Subject: Clinton Power Station Unit 1
Humphrey Concerns

Reference: IP letter U-0596 dated 2/4/83, G. E. Wuller to
A. Schwencer, NRC, subject: Submittal addressing
some John Humphrey concerns.

The referenced letter addressed some of the John Humphrey concerns as applicable to the Clinton Power Station (CPS). Enclosed are CPS responses on some additional Humphrey issues for NRC Staff review. Included are Action Plans #15, 18, 19, 22, 25, 28, 31 and 32. We believe that these responses will resolve the particular concern involved.

FIGURE 19.1 CONTAINMENT BYPASS LEAKAGE CAPABILITY

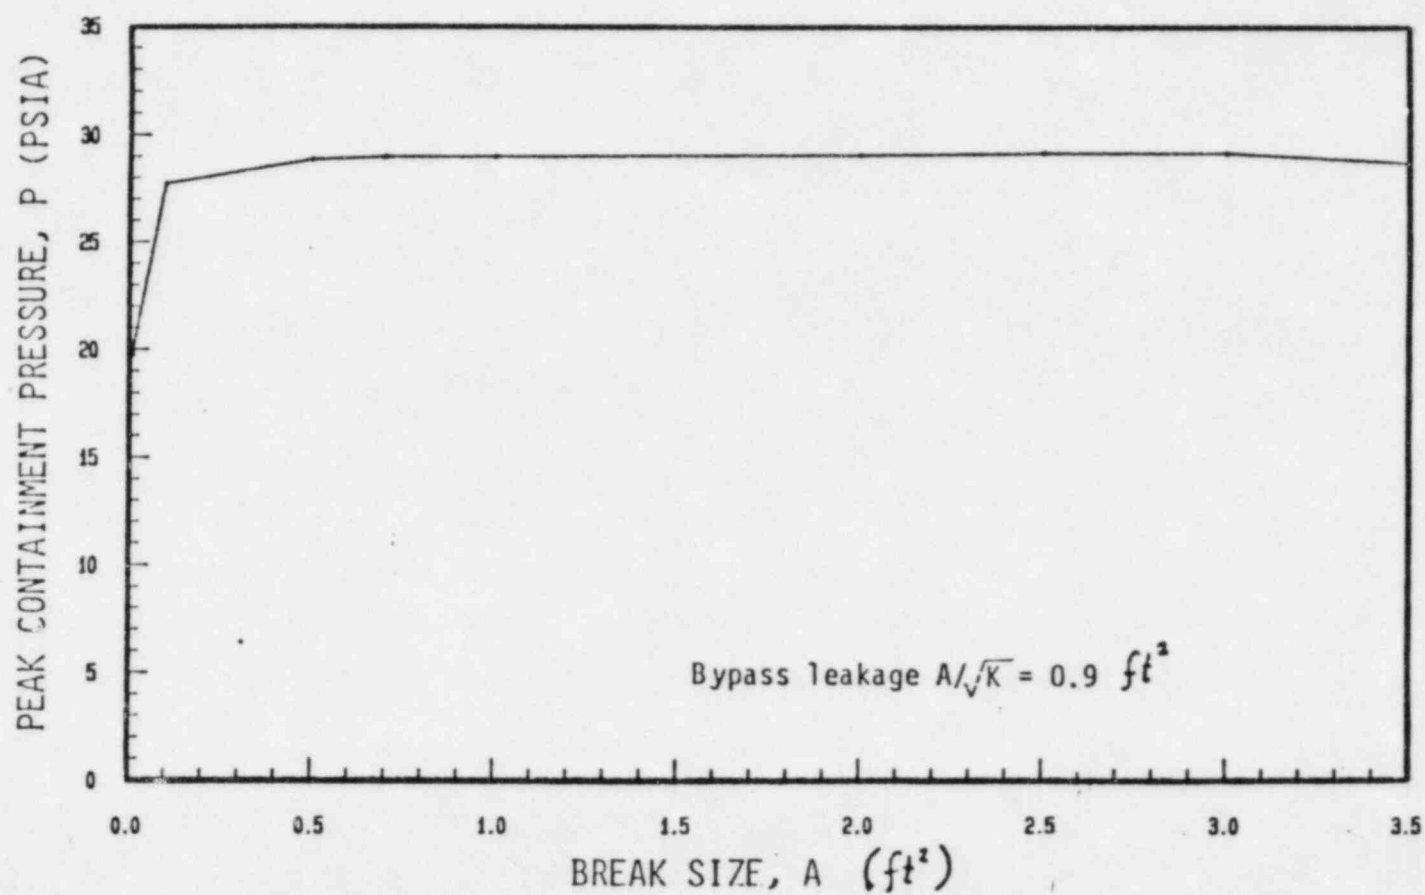
- 5.1 The worst case of drywell to containment bypass leakage has been established as a small break accident. An intermediate break accident will actually produce the most significant drywell to containment leakage prior to initiation of containment sprays.
- 5.6 The test pressure of 3 psig specified for the periodic operational drywell leakage rate tests does not reflect additional pressurization in the drywell which will result from upper pool dump. This pressure also does not reflect additional drywell pressurization resulting from throttling of the ECCS to maintain vessel level which is required by the current EPG's.
- 9.2 The continuous steaming produced by throttling the ECCS flow will cause increased direct leakage from the drywell to the containment. This could result in increased containment pressures.

In response to 19.1 and 19.2 a spectrum of breaks ranging from SBA to DBA with a bypass leakage equivalent area of $A/\sqrt{K} = 0.9 \text{ ft}^2$ were analyzed to determine the degree of containment pressurization prior to the initiation of containment spray. The analyses were performed using GE proprietary computer program VACBR04. Structural heat sinks and heat and mass transfer between suppression pool and containment air space were considered in the model. Free convection heat transfer coefficients were conservatively calculated to minimize the heat sink effectiveness. The duration of drywell pressurization is maximized by assuming that the operator controls the RPV water level, in a manner such that the break will not be flooded by ECCS system operation. Thus, there is no drywell steam condensation caused by a relatively cool break liquid flowing into the drywell to promote condensation.

The analyses show that the limiting drywell to containment bypass leakage results from a 2.5 ft^2 steam-line break accident. The peak containment pressure in this case, at the time of spray initiation, was 14.5 psig - which is below the containment design pressure of 15 psig. Therefore, the previously calculated bypass leakage capability of $A/\sqrt{K} = 0.9 \text{ ft}^2$ for GGNS is still valid. This analysis envelopes CPS even though the bypass leakage A/\sqrt{K} for Clinton is 1.0 ft^2 . The bypass leakage variable is not as significant in the analysis as the structural heat sinks and the heat and mass transfer between the suppression pool and containment air space. These heat sinks and heat and mass transfer coefficients used in the analysis are conservative for Clinton.

Figure 19.1 shows the peak containment pressure as a function of break size, with bypass leakage of $A/\sqrt{K} = 0.9 \text{ ft}^2$.

It is therefore concluded that there is no need for reducing the allowable bypass leakage technical specification in consideration of the additional pressure produced by upper pool dump. Thus, this issue is closed for Clinton.

FIGURE 25-1 SENSITIVITY OF CONTAINMENT PRESSURE TO DRYWEAL INITIAL CONDITIONS

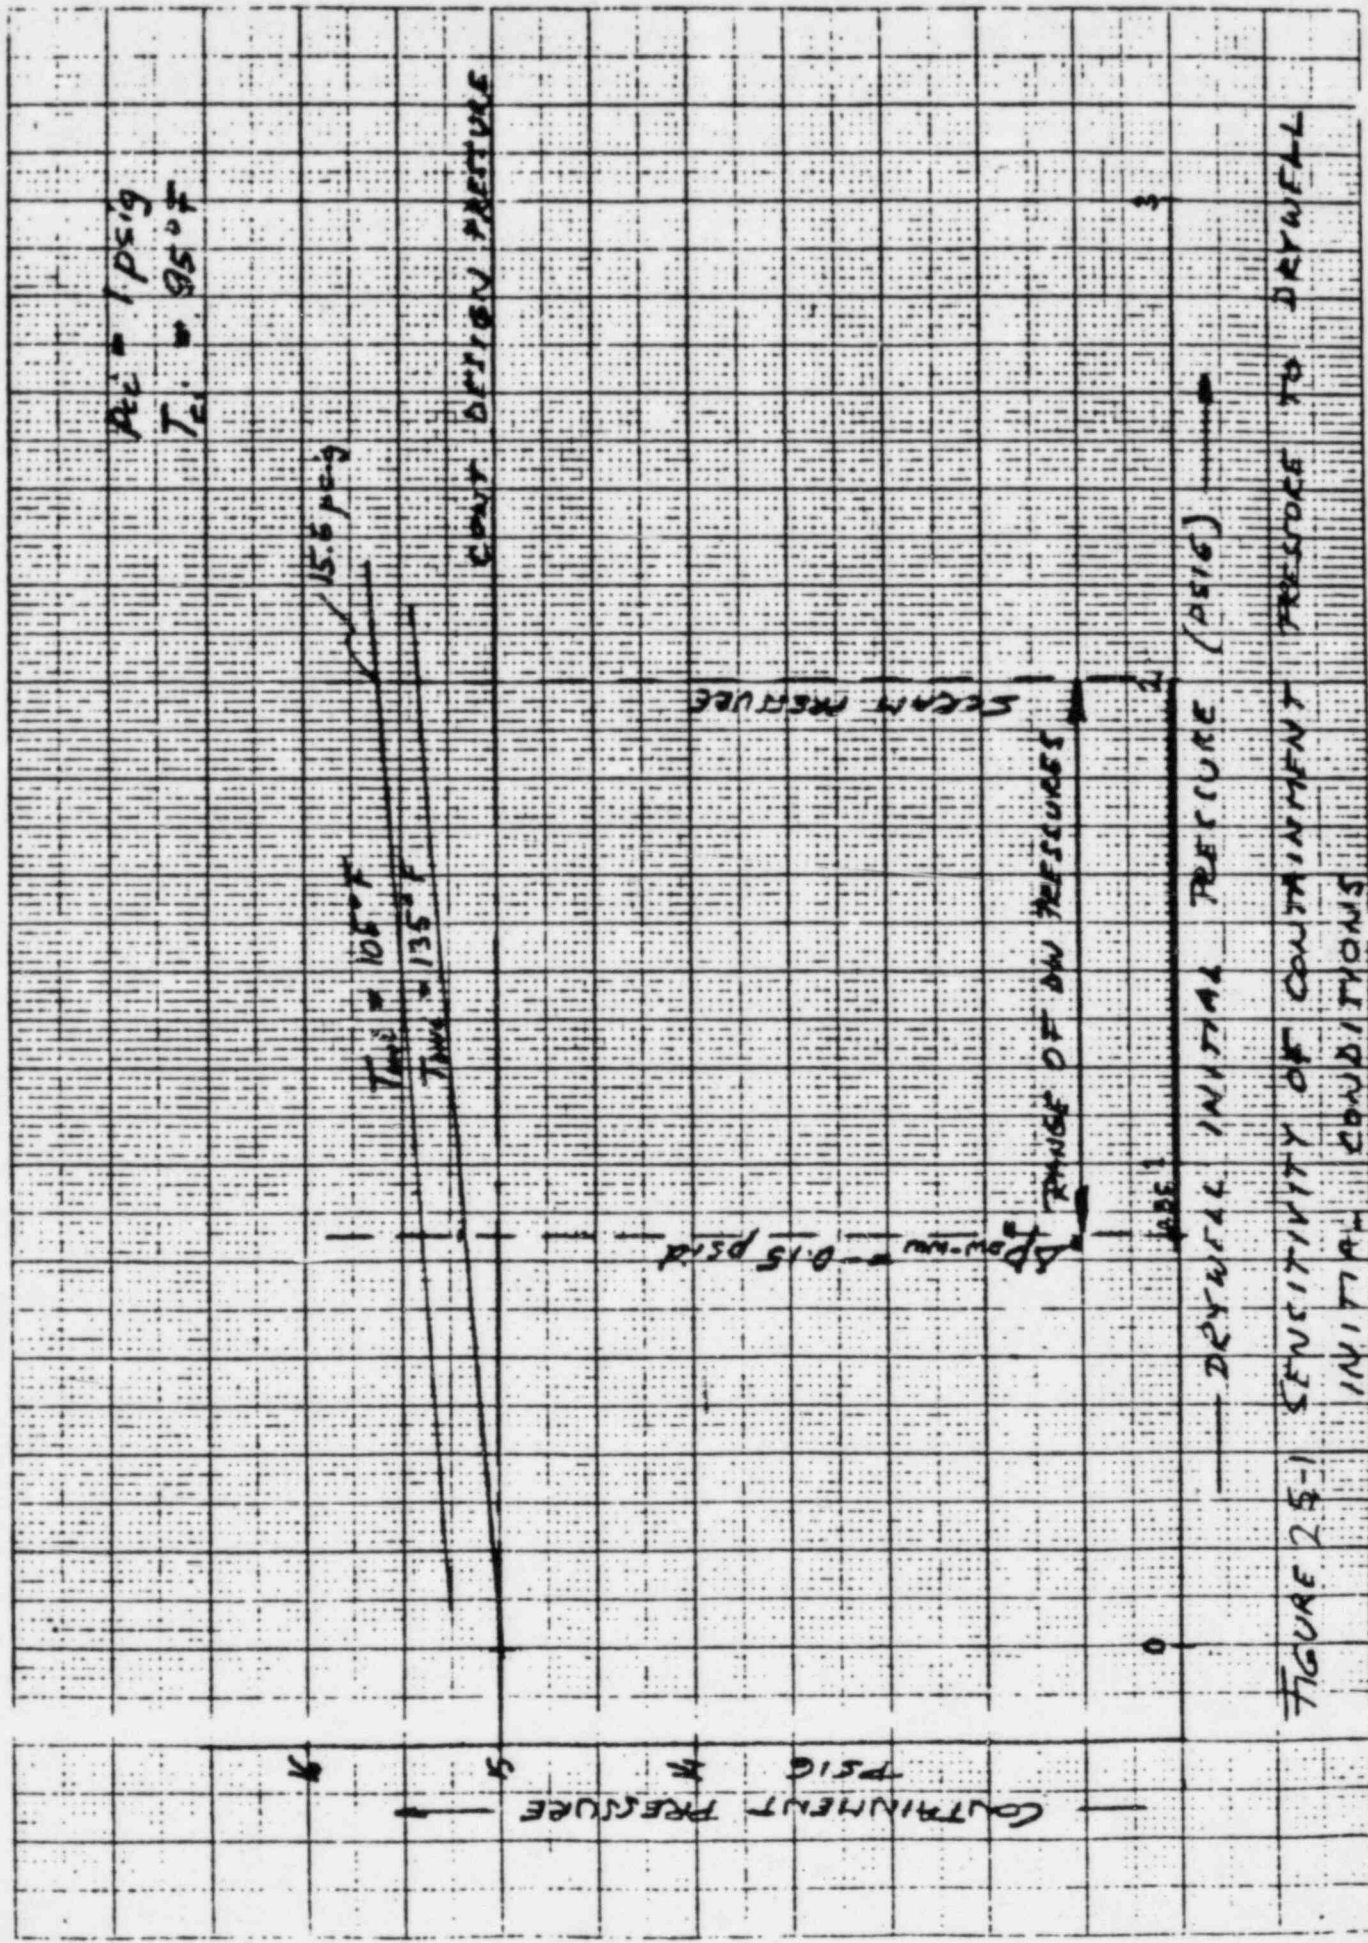
- 8.1 This issue is based on consideration that some technical specifications allow operation at parameter values that differ from the values used in assumptions for FSAR transient analyses. Normally analyses are done assuming a nominal containment pressure equal to ambient (0 psig) a temperature near maximum operating (90°F) and do not limit the drywell pressure equal to the containment pressure. The technical specifications permit operation under conditions such as a positive containment pressure (1.5 psig), temperatures less than the maximum (60 or 70°F) and drywell pressure can be negative with respect to the containment (-0.5 psid). All of these differences would result in transient response different than the FSAR descriptions.

The Containment Issues Owners Group (CIOG) has continued to evaluate varying combinations of conservative initial containment and drywell conditions. The CIOG has expanded the range of initial drywell pressures evaluated up to an initial drywell pressure that initiates reactor scram and generates a LOCA signal. These studies computed the peak containment pressure under hypothetical conditions where containment design temperatures of 185°F, and 100% RH, are attained in the containment airspace. The entire drywell air mass is assumed to be transferred to the containment with no redistribution to the drywell. The resulting sensitivity trend to varying initial drywell pressure, under "worst-case" initial conditions for all other parameters, is given in Figure 25-1 for initial drywell temperatures of 105°F and 135°F.

These results are excessively conservative with respect to GGNS & CPS. As noted in reference 1, the actual calculated peak long term post accident containment temperature is 180°F assuming that thermal equilibrium exists between the suppression pool and the containment air space. This is lower than the end point temperature used in the CIOG sensitivity study. The CIOG analyses also include the vapor pressure of water at 185°F which is also higher than the vapor pressure which would be predicted at GGNS & CPS using the conservative licensing basis assumptions. In addition, the air volume ratio of containment to drywell at CPS is 21% higher than the volume ratio considered in the CIOG analysis.

These results show that under excessively conservative, non-realistic assumptions and a methodology which neglects operator mitigating actions (EPG procedures), it is possible to compute end-point states for the containment airspace which exceed the containment design pressure. The CIOG does not believe that such end-point calculation results are appropriate for assessing the adequacy of containment design. The CIOG feels that no purpose is served in pursuing further contrived end-point computations of this nature and, accordingly, no further analysis on this issue is planned.
